FIELD CHANGE AUTHORIZATION

BABCOCK & WILCOX

CUSTOMER FLORIDA POWER CORP.	ORIGINATOR <i>J.F. Eschbach</i>	DATE <i>4-28-79</i>	CONT. NO. <i>620-CC-704-3110</i>	DOC. I.D. <i>3110</i>	PCA NO. <i>00</i>	REV. NO. <i>00</i>
SUPPLIER	P.A. NO.	PART NO., OR.	TASK NO.	GROUP NO.	SEQ. NO.	
TITLE (MAX 30 CHARACTERS) Reactor Trip on Loss of FWP & Turbine Trip			<i>21</i>	<i>001</i>	<i>001</i>

Implement reactor trip upon loss of both main feedwater pumps or upon turbine trip.

SHEET 5 OF 10

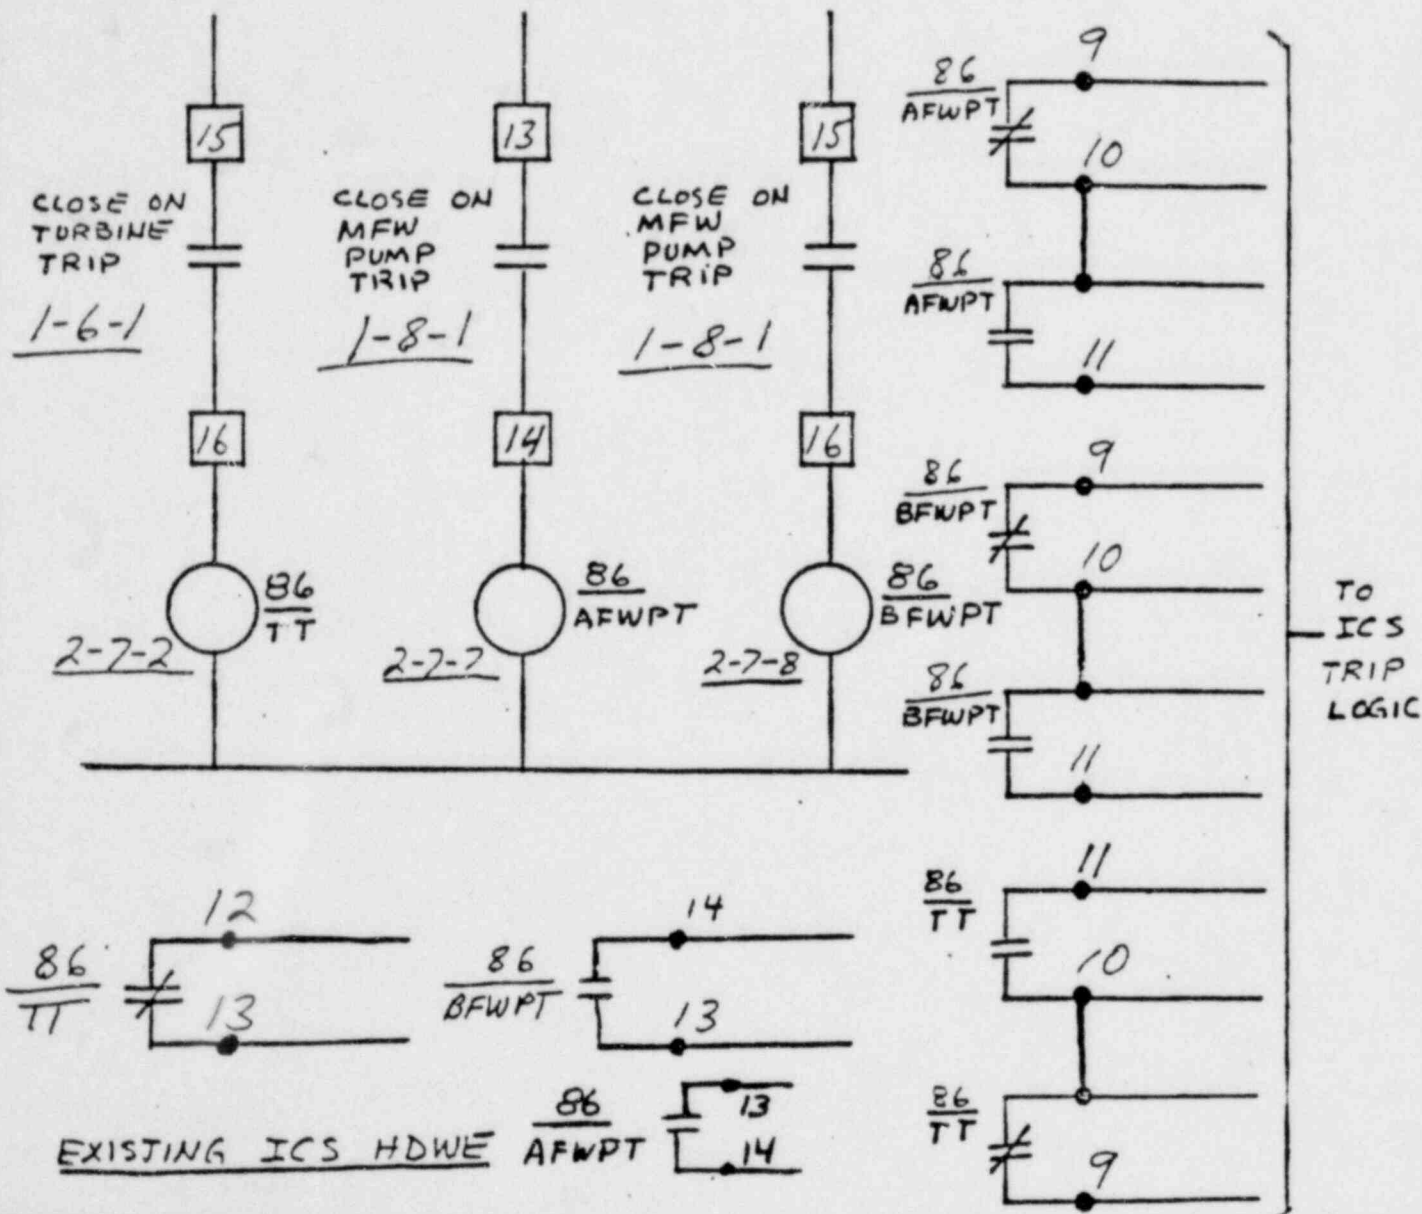
Utilizing a wire wrap tool and 22 AWG solid strand wire, connect the relays, switches and power per the attached two sketches. Power connection to be the + 24Vdc bus within the cabinet

SHEET 6 OF 10

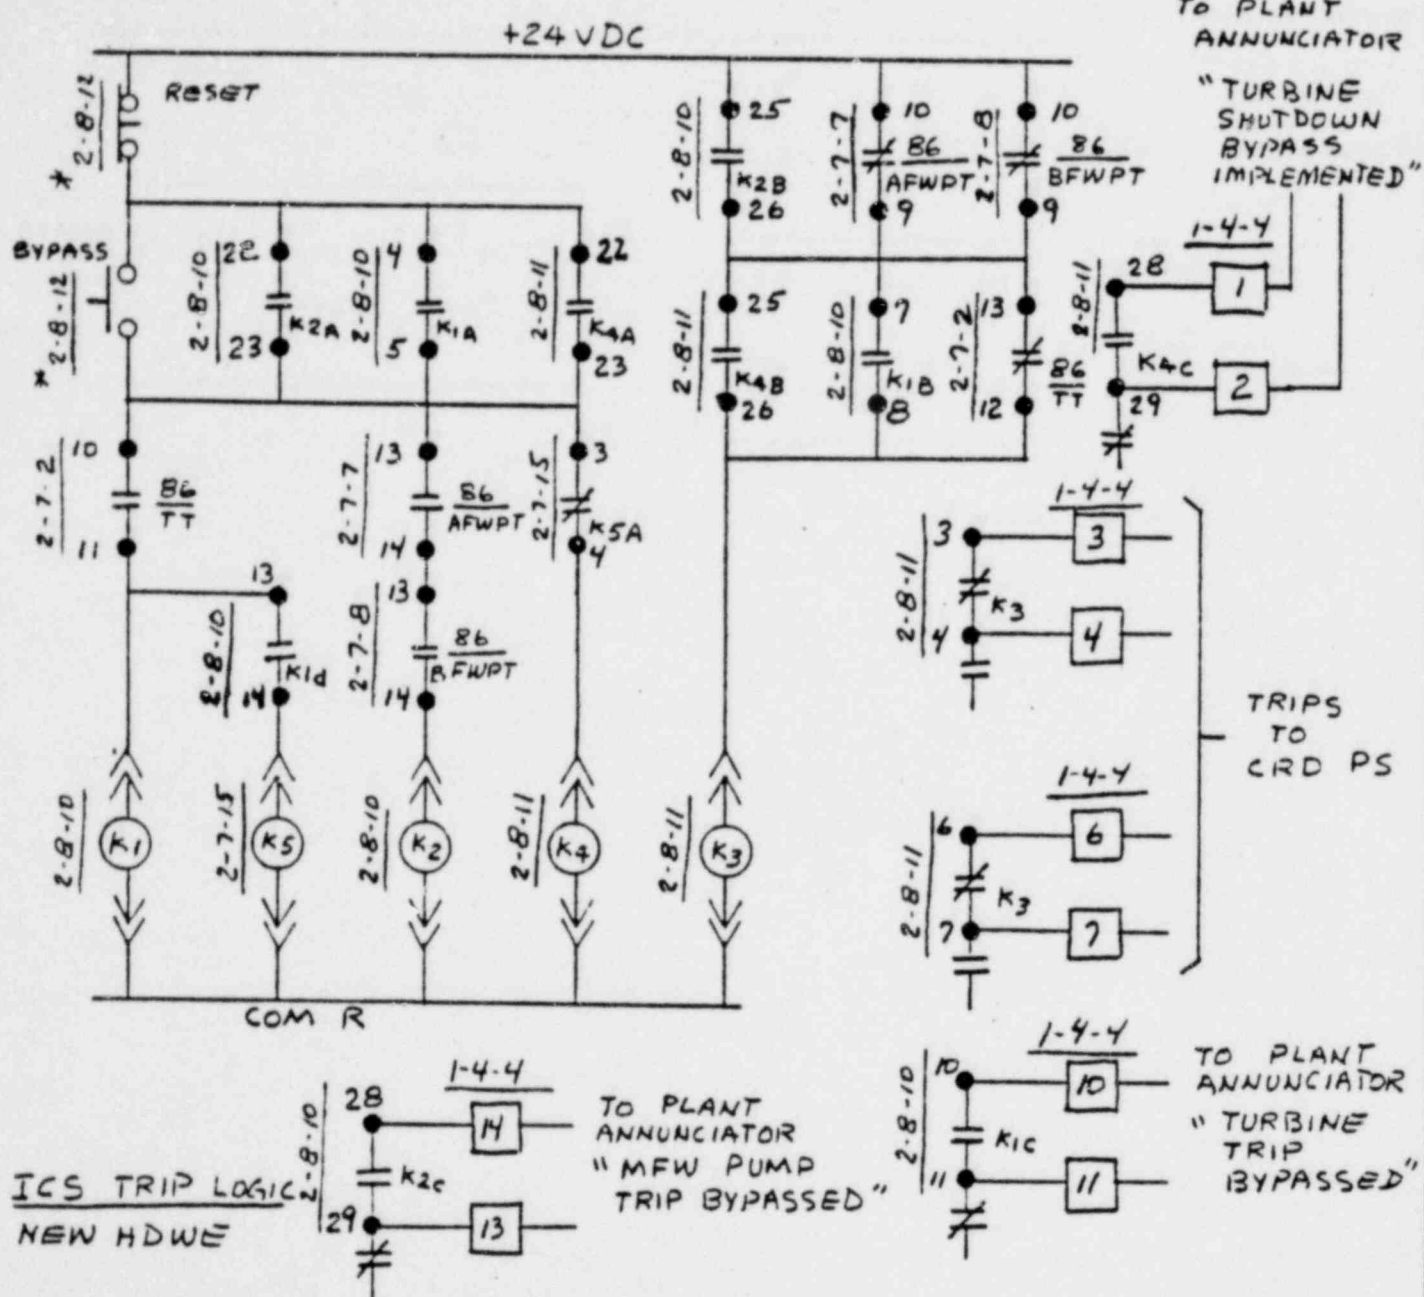
Install the bypass and reset switches. The suggested installation location is on the blank cover located in cabinet 2 row 7 position 5.

* RECOMMENDED LOCATION OF BYPASS AND RESET SWITCHES.

TRIP BREAKER 3

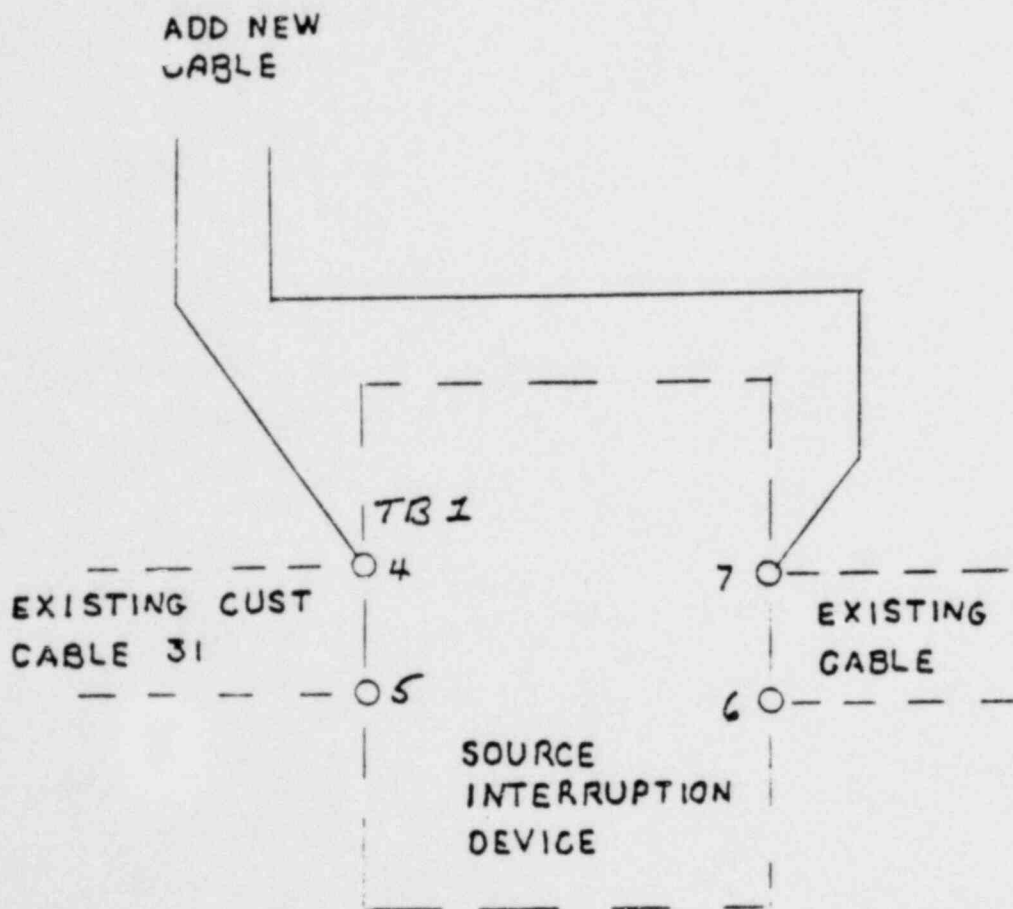
1. Remove all power from the AC breaker cabinet before starting.
2. Locate TBI on the source interruption device of AC breaker cabinet A and B.
3. Add a new cable between the source interruption device A of AC breaker cabinet A and the ICS.
4. Add a new cable between the source interruption device B of AC breaker cabinet B and the ICS.
5. The termination of the cable on each source interruption device shall be as shown on sheets 2 and 3.
6. The termination of the cable on the ICS shall be as shown on the sheets for Task 21 (ICS).
7. The cables should be two conductor, 14 ga AWG.
